Module 1.8 Construction

(To include temporary access routes)

Modified Access Routes

Figure 9

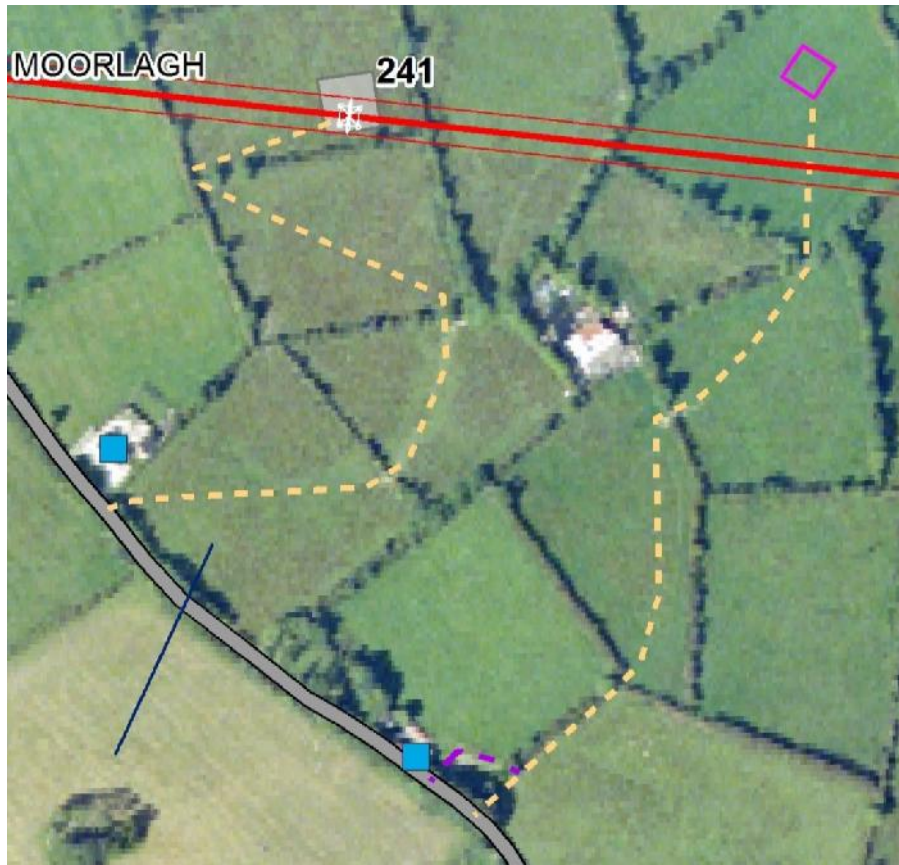
Environmental Review Topic	Tower 242 Stringing Access Route Comment
Ecology	The route delineated in purple utilises an existing road access, in addition to an existing access within the field boundary. There is no change to the overall ecological impact evaluation.
Cultural Heritage	There are no cultural heritage issues with the proposed alternative route.
Traffic	Both access routes are via the same local road; with the alternative utilising an existing entrance. There is no change to traffic movements.
Water/Soils/Geology	Soil and subsoil types are similar for both routes, as is the water environment; therefore there are no significant impacts identified.
Agronomy	The route delineated in purple could potentially increase disturbance as it passes through a farm entrance; however, this will not change the overall impact on this land parcel.

Figure 10

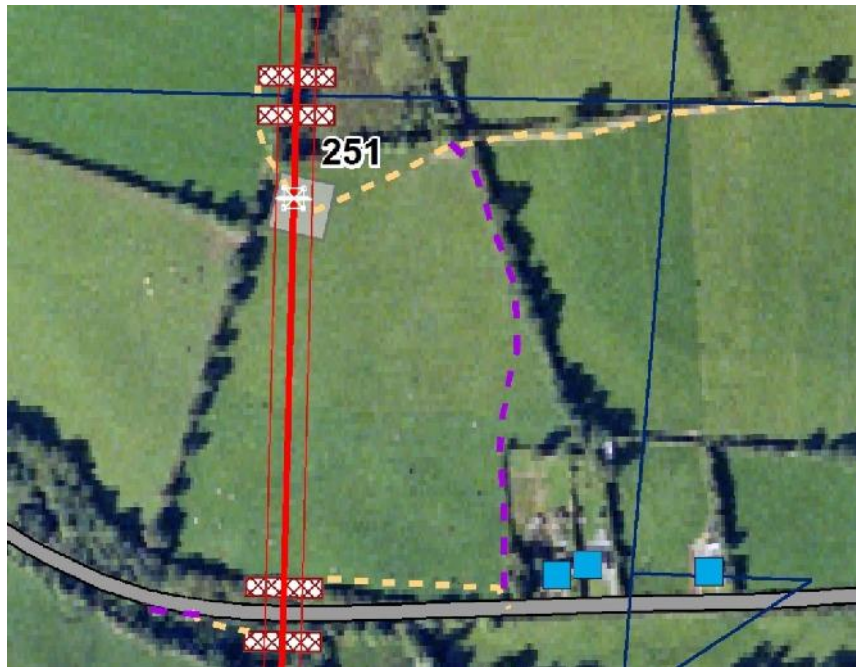
Environmental Review Topic	Tower 251/252 Access Route Comment
Ecology	The access route to the northern guarding, delineated in purple, uses an existing gap in the hedgerow in the northeast corner of the field, crossing improved agricultural grassland. The access to the southern guarding, also delineated in purple, will use an existing gap in the hedgerow, which is currently fenced with wire fencing. There is no change to the overall ecological impact evaluation.
Cultural Heritage	There are no cultural heritage issues identified with either of these modifications.
Traffic	Access to guarding on north side of L6801 now via access route to Tower 251. No change to daily maximum peak traffic envisaged along haul routes.
Water/Soils/Geology	Both routes are across similar soil and subsoil types, the water environment is also similar. No significant issues with either access route option.
Agronomy	The access route to the northern guarding, delineated in purple, stays close to the field boundary and uses an existing farm track. The additional effects arising from either of the modified routes are not significant and would not change the overall impact evaluation.

Figure 12

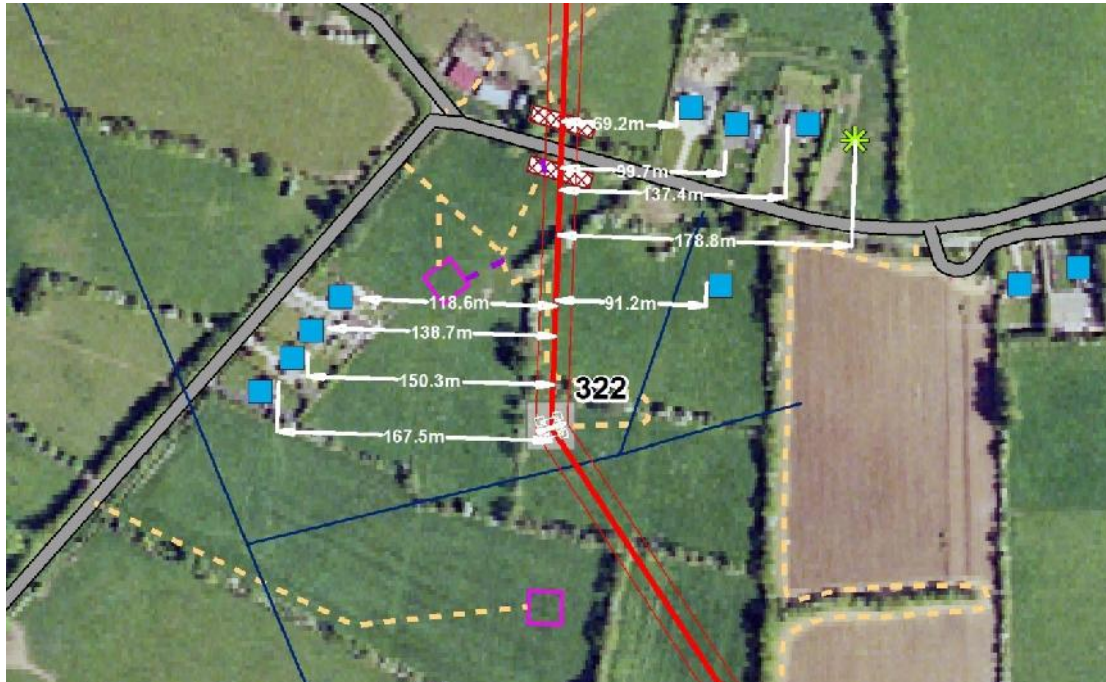
Environmental Review Topic	Tower 322 guarding and stringing Access Route Comment
Ecology	The access route delineated in purple uses an existing gap in the hedgerow in the north of the field, crossing improved agricultural grassland to the tower. The route shown in purple does not require a change to the overall ecological impact evaluation.
Cultural Heritage	Archaeological monitoring at the guarding adjacent to the proposed access has been specified in the EIS. There are no cultural heritage issues with the access route delineated in purple.
Traffic	Access to guarding and Tower 322 is via existing field gate on south side of L400453. No change to daily maximum peak traffic is envisaged along haul routes.
Water/Soils/Geology	Soil and subsoil types are similar for both routes, as is the water environment; therefore there are no significant impacts identified.
Agronomy	The route delineated in purple reduces the length of access route required within the land parcel. The reduced length will not change the overall impact on this land parcel.

Figure 15

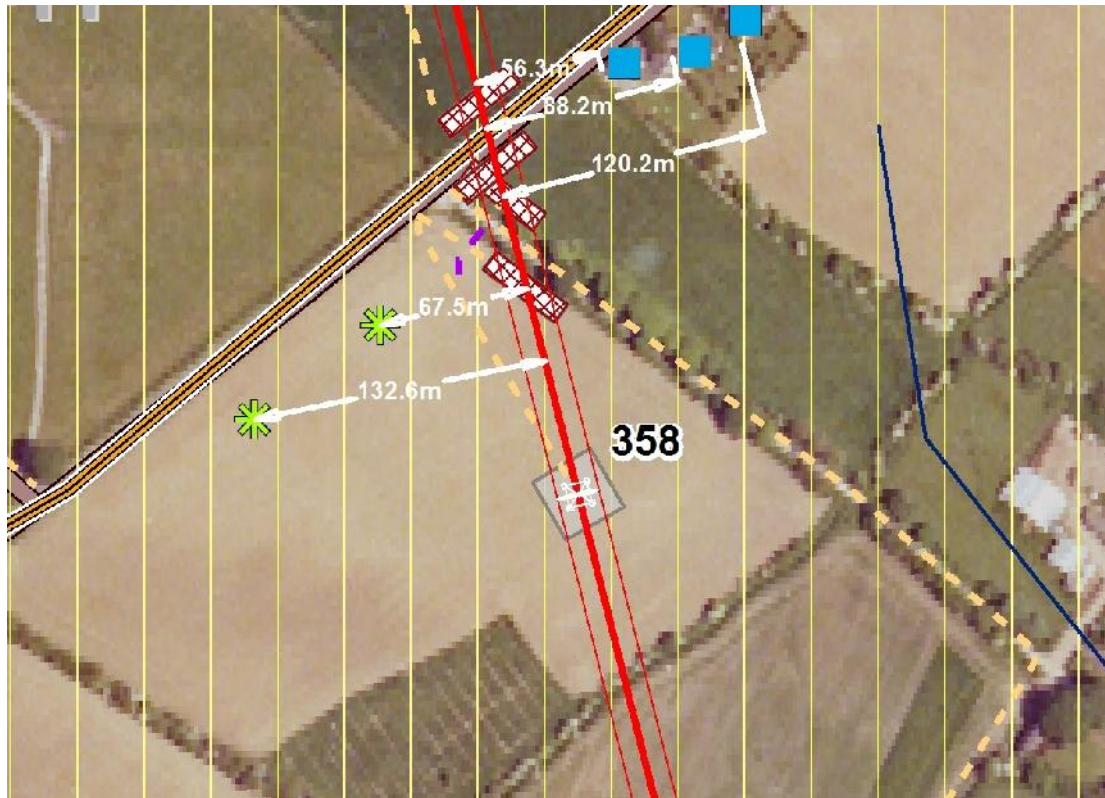
Environmental Review Topic	Tower 358 and Guarding Access Route Comment
Ecology	The access route delineated in purple, within the context of the improved agricultural land and managed hedgerows, will not have any appreciable effect on the significance of the ecological impact evaluation at this location. There is no change to the overall ecological impact evaluation.
Cultural Heritage	There are no cultural heritage issues with the access route delineated in purple.
Traffic	Access to Tower 358 is via the same local road (L22051). There is no change to traffic movements.
Water/Soils/Geology	Soil and subsoil types are similar for both access routes, as is the water environment; therefore there are no significant impacts identified.
Agronomy	The proposed route delineated in purple is similar in length to the original proposal and will not significantly change the overall impact on this land parcel.

Figure 16

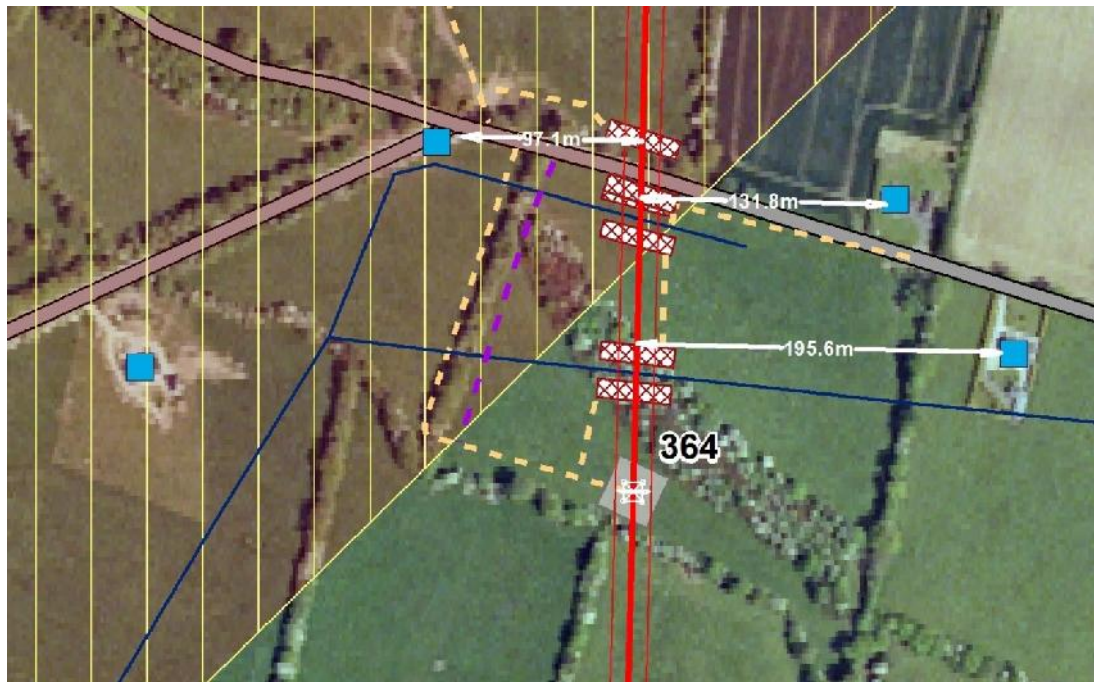
Environmental Review Topic	Tower 364 Access Route Comment
Ecology	The route delineated in purple uses an existing access from the road and an existing access within the field. This will not have any appreciable effect on the significance of the overall ecological impact evaluation.
Cultural Heritage	There are no cultural heritage issues with the access route delineated in purple; utilising the existing road entrance and field access for the alternative route is preferred.
Traffic	Access to Tower 364 is via the same local road, where the route delineated in purple will use an existing entrance gate. There is no change to traffic movements.
Water/Soils/Geology	Soil and subsoil types are similar for both access routes, as is the water environment; therefore there are no significant impacts identified.
Agronomy	The route delineated in purple is similar in length to the original proposal, but utilises an existing entrance gate and will not significantly change the impact on this land parcel.

Figure 17

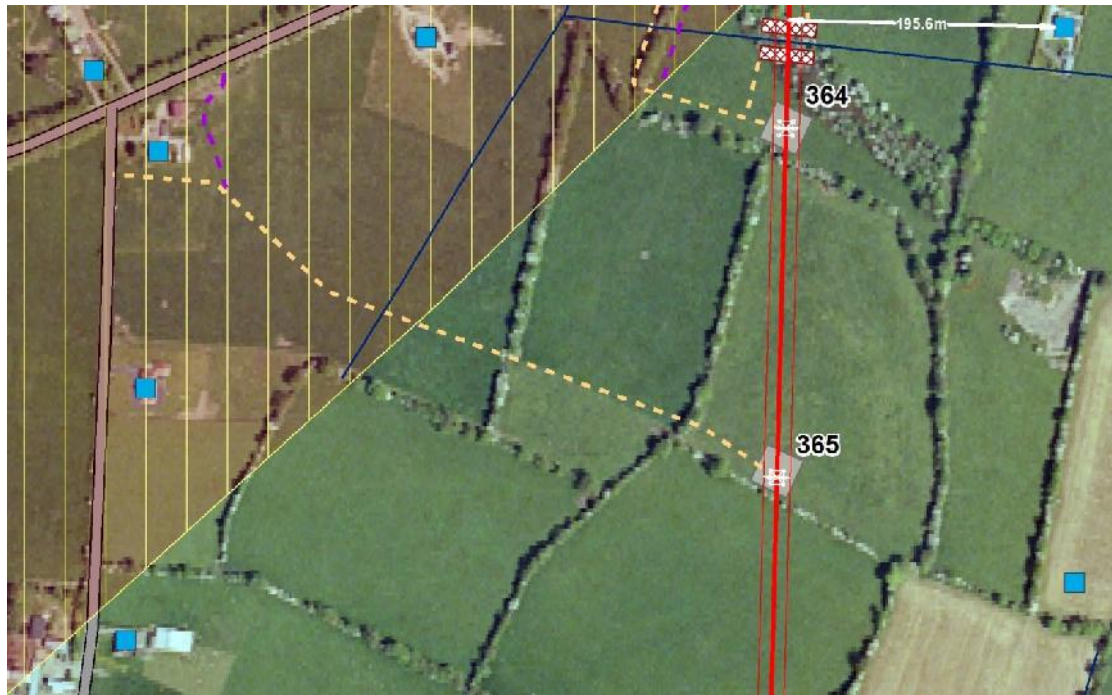
Environmental Review Topic	Tower 365 and Guarding Access Route Comment
Ecology	The access route delineated in purple uses existing access at the farm premises. This will not have any appreciable effect on the significance of the overall ecological impact evaluation.
Cultural Heritage	There are no cultural heritage issues with the access route delineated in purple.
Traffic	Access to Tower 365 is via a tertiary road to the north, utilising an existing access at a farm premises. There is no change to traffic movements.
Water/Soils/Geology	Soil and subsoil types are similar for both access routes, as is the water environment; therefore there are no significant impacts identified.
Agronomy	The access route delineated in purple is of a similar length and uses an existing farmyard entrance, potentially increasing temporary disturbance. However, this will not significantly change the impact on this land parcel.

Figure 18

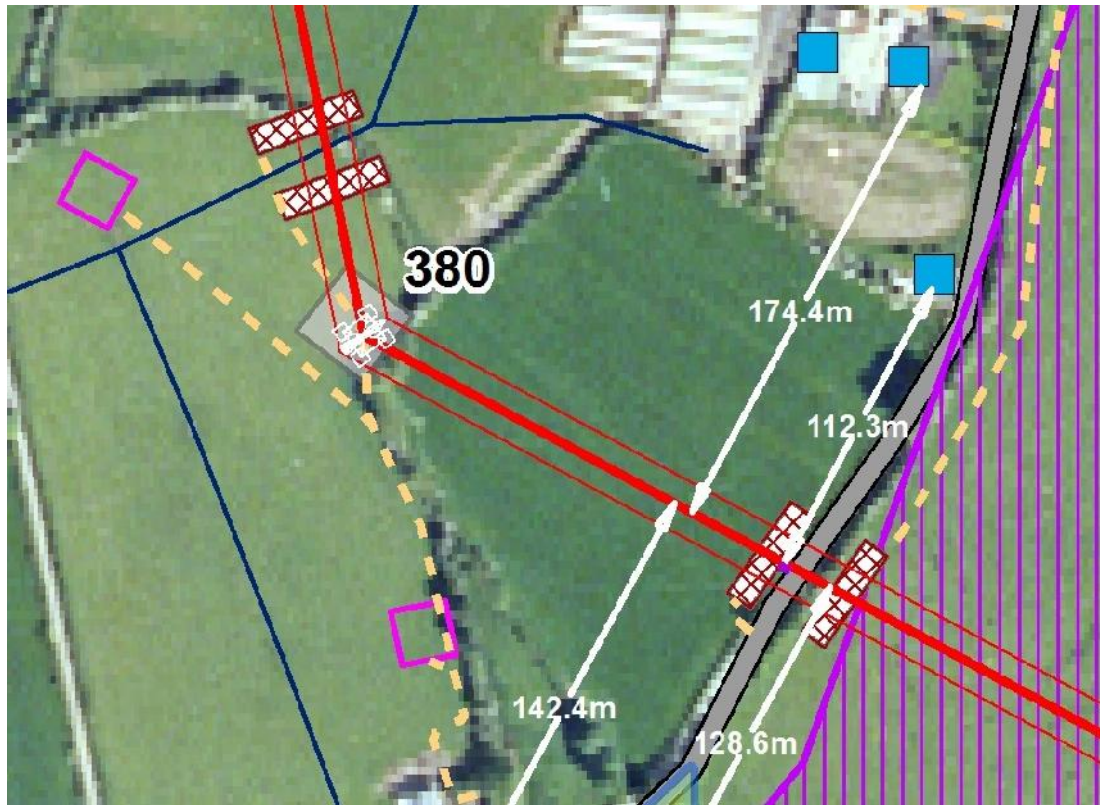
Environmental Review Topic	Tower 380 Guarding Access Route Comment
Ecology	The access route shown in purple, within the context of the improved agricultural land and managed hedgerows, will not have any appreciable effect on the significance of the ecological impact evaluation at this location.
Cultural Heritage	There are no cultural heritage issues with the access route delineated in purple.
Traffic	Access to Tower 380 is via the same public road. There is no change to traffic movements.
Water/Soils/Geology	Soil and subsoil types are similar to the previous route, as is the water environment; therefore there are no significant impacts identified.
Agronomy	The route delineated in purple is slightly shorter in length than the original proposal and utilises an existing entrance gate. The route shown in purple will not significantly change the overall impact on this land parcel.
